**NEW YORK STATE THRUWAY AUTHORITY
DEPARTMENT OF ENGINEERING**

**AMENDMENT NO. 2
TO**

**CONTRACT TAN 26-14
D215082
PAVEMENT REHABILITATION AND MISCELLANEOUS
WORK ON I-190, NIAGARA THRUWAY
FROM MP N0.7 TO MP N4.2
IN THE BUFFALO DIVISION
OF THE NEW YORK STATE THRUWAY
IN ERIE COUNTY**

**IN THE LETTING OF
FEBRUARY 25, 2026**

**DRAINAGE STRUCTURE WALL REPAIR
IN MEDIAN DETAIL**
ITEM 604.070502
NOTE 10
NTS

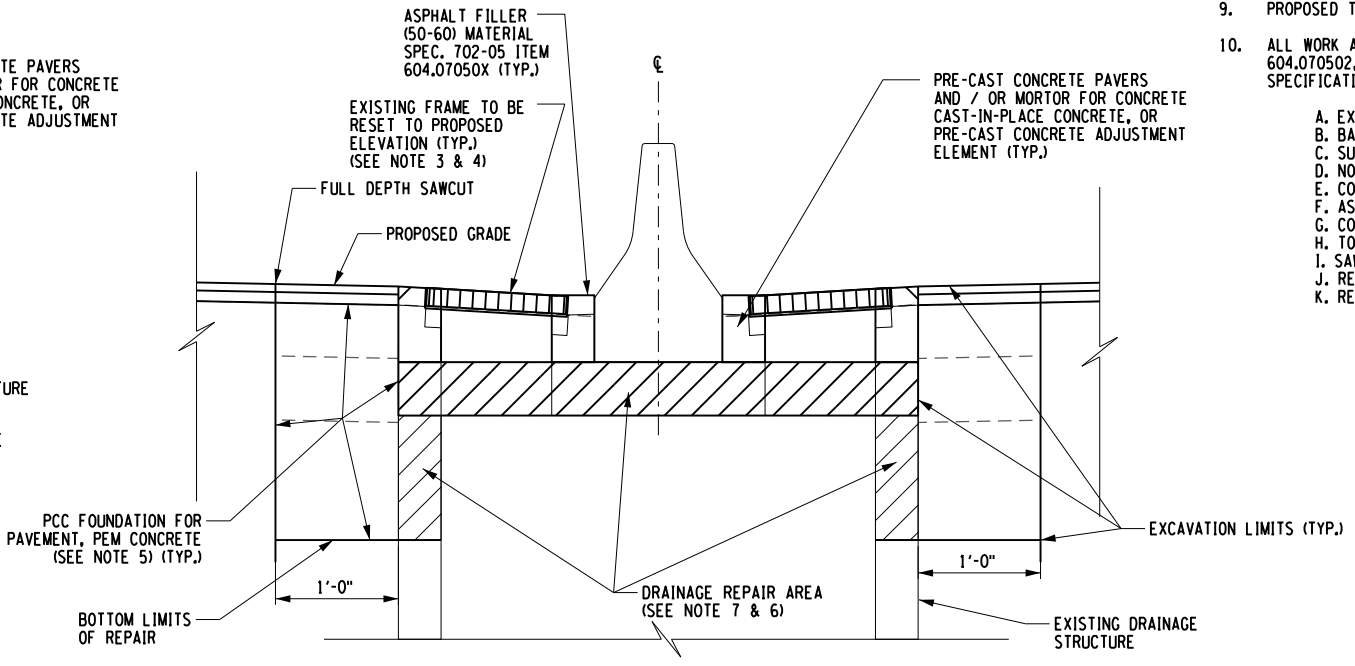
17. **DELETE** Drawing Number MD-5, Sheet 194 of 421, and **SUBSTITUTE** with the attached Drawing Number MD-5, Sheet 194-A2 of 421. The “Drainage Structure Wall Repair in Median Detail” was updated to show limits of repair.

TITLE OF PROJECT I-190 HIGHWAY REHABILITATION	CONTRACT NUMBER: TAN 26-14
	LOCATION OF PROJECT I-190 NIAGARA THRUWAY MP 900.7 TO MP 904.2	DATE: FEB. 2026
	TITLE OF DRAWING ROADWAY PLANS	DRAWING NUMBER: PL-1

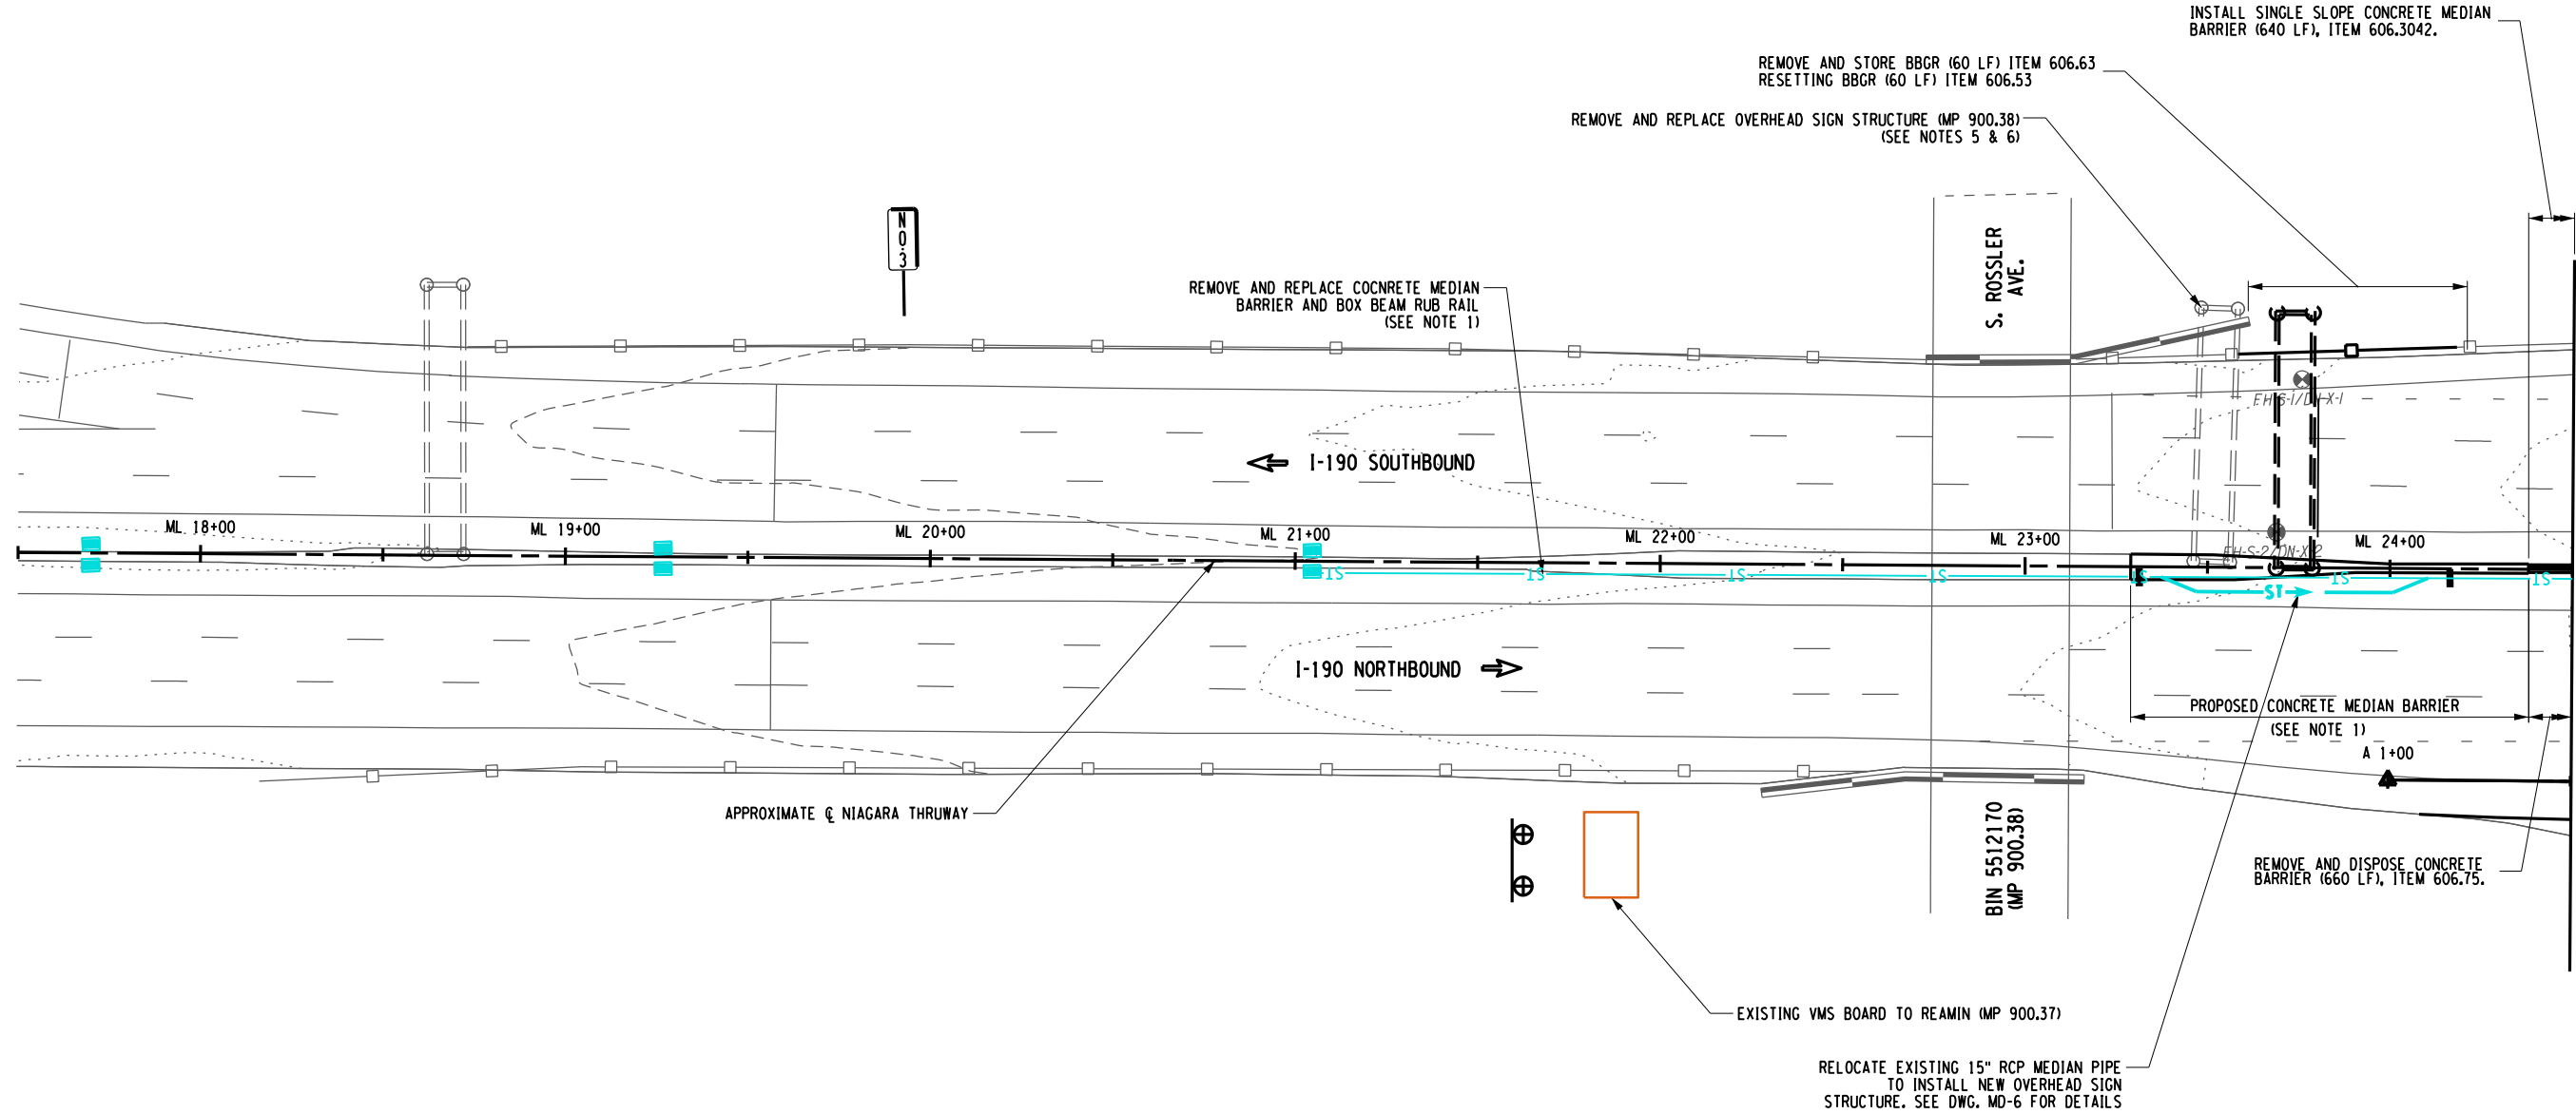
19. **DELETE** Drawing Number PL-1, Sheet 270 of 421, and **SUBSTITUTE** with the attached Drawing Number PL-1, Sheet 270-A2 of 421. Updated limits of callouts of removal and placement for concrete median barrier.

TITLE OF PROJECT I-190 HIGHWAY REHABILITATION	CONTRACT NUMBER: TAN 26-14
LOCATION OF PROJECT I-190 NIAGARA THRUWAY MP 900.7 TO MP 904.2	DATE: FEB. 2026
TITLE OF DRAWING ROADWAY PLANS	DRAWING NUMBER: PL-2

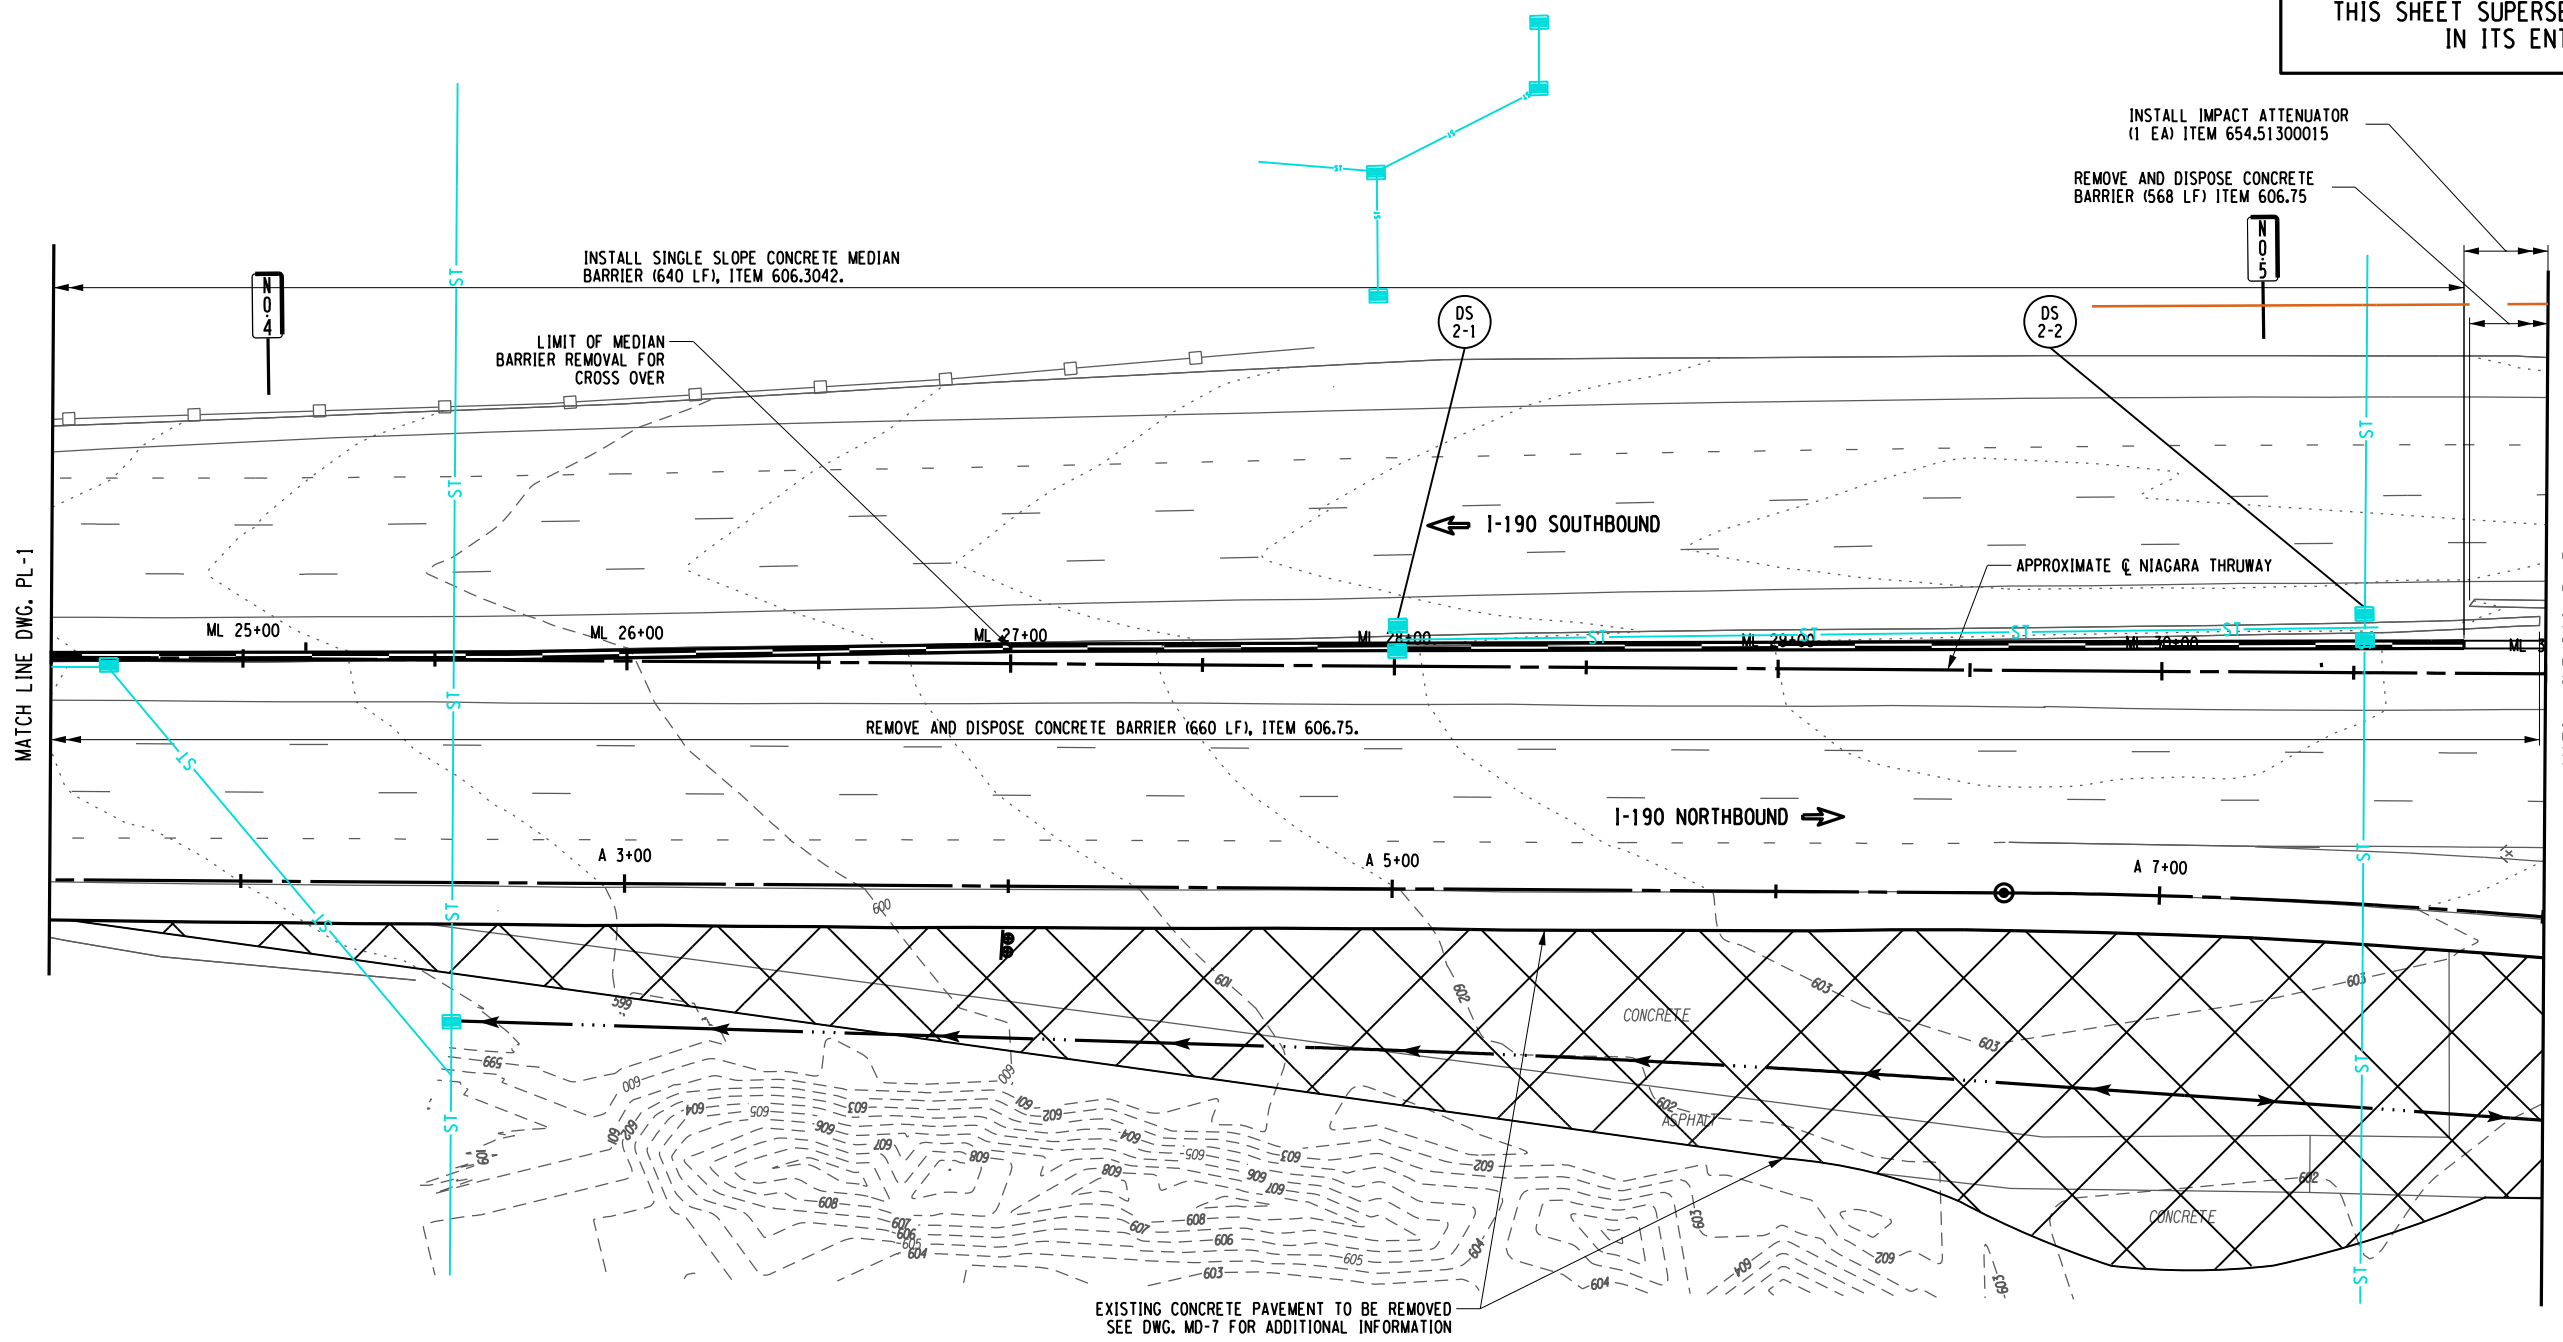
20. **DELETE** Drawing Number PL-2, Sheet 271 of 421, and **SUBSTITUTE** with the attached Drawing Number PL-2, Sheet 271-A2 of 421. Updated limits of callouts of removal and placement for concrete median barrier.

TITLE OF PROJECT I-190 HIGHWAY REHABILITATION	CONTRACT NUMBER: TAN 26-14
LOCATION OF PROJECT I-190 NIAGARA THRUWAY MP 900.7 TO MP 904.2	DATE: FEB. 2026
TITLE OF DRAWING ROADWAY PLANS	DRAWING NUMBER: PL-3

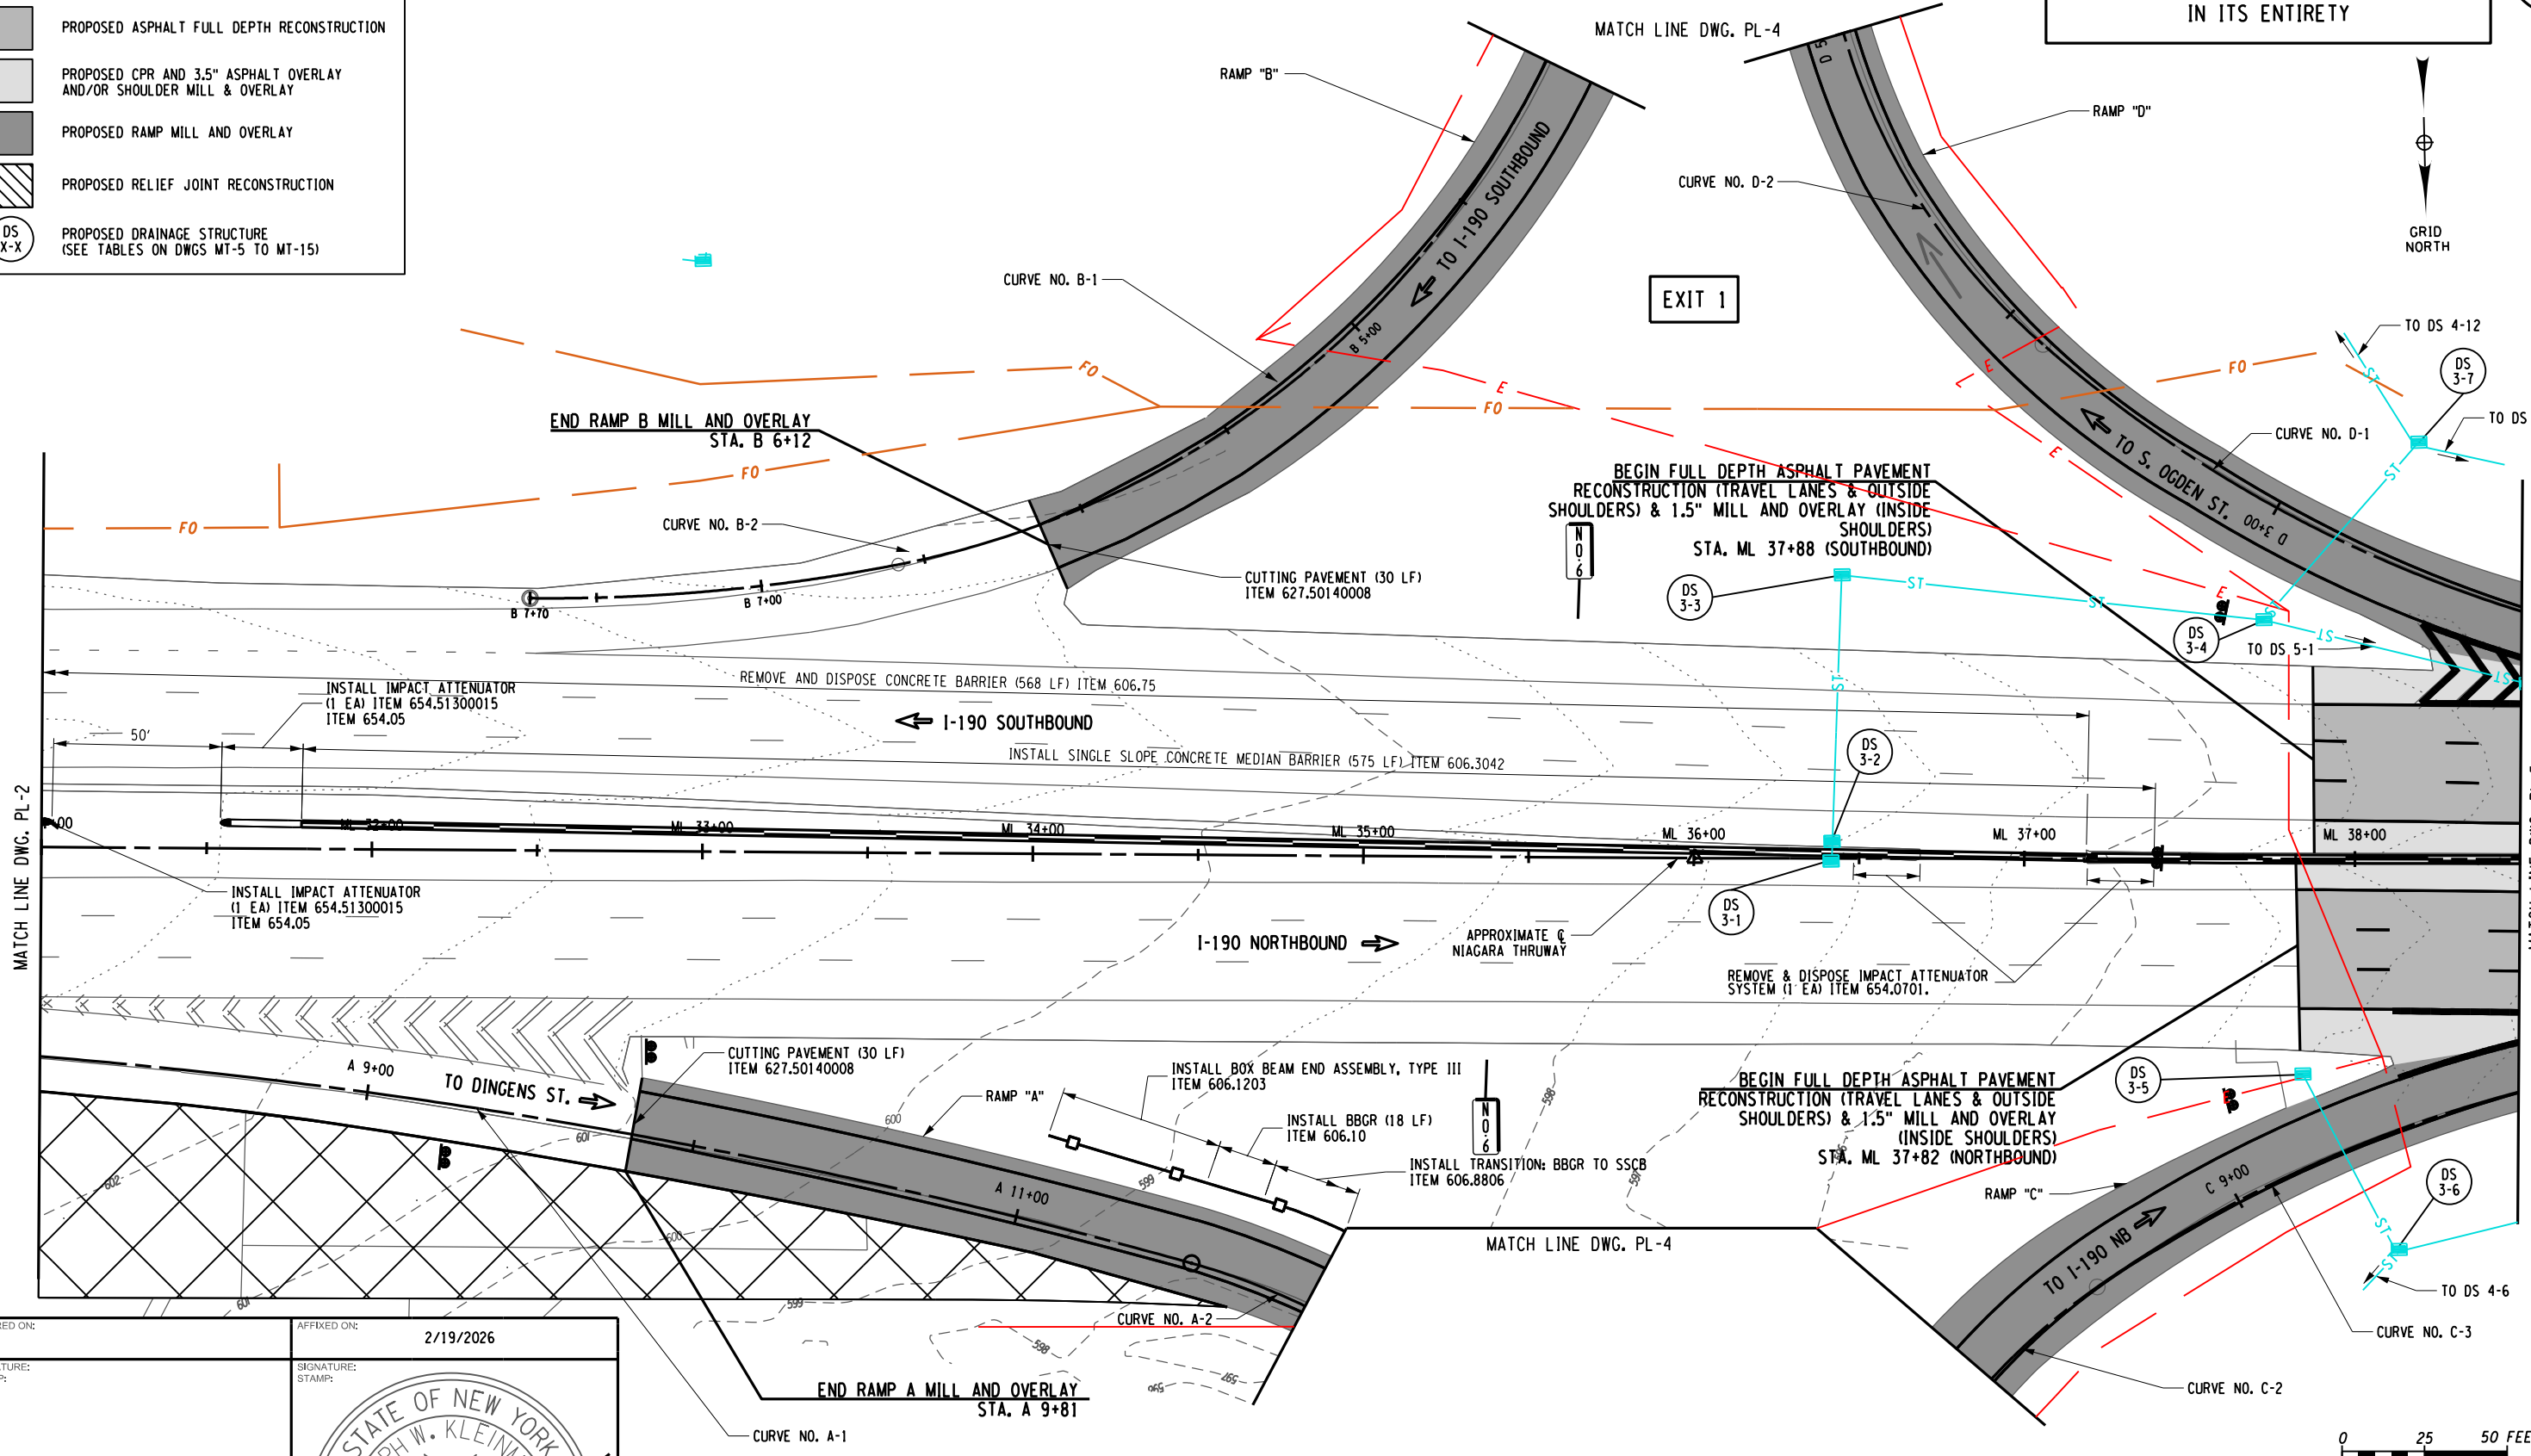
21. **DELETE** Drawing Number PL-3, Sheet 272 of 421, and **SUBSTITUTE** with the attached Drawing Number PL-3, Sheet 272-A2 of 421. Updated limits of callouts of removal and placement for concrete median barrier.
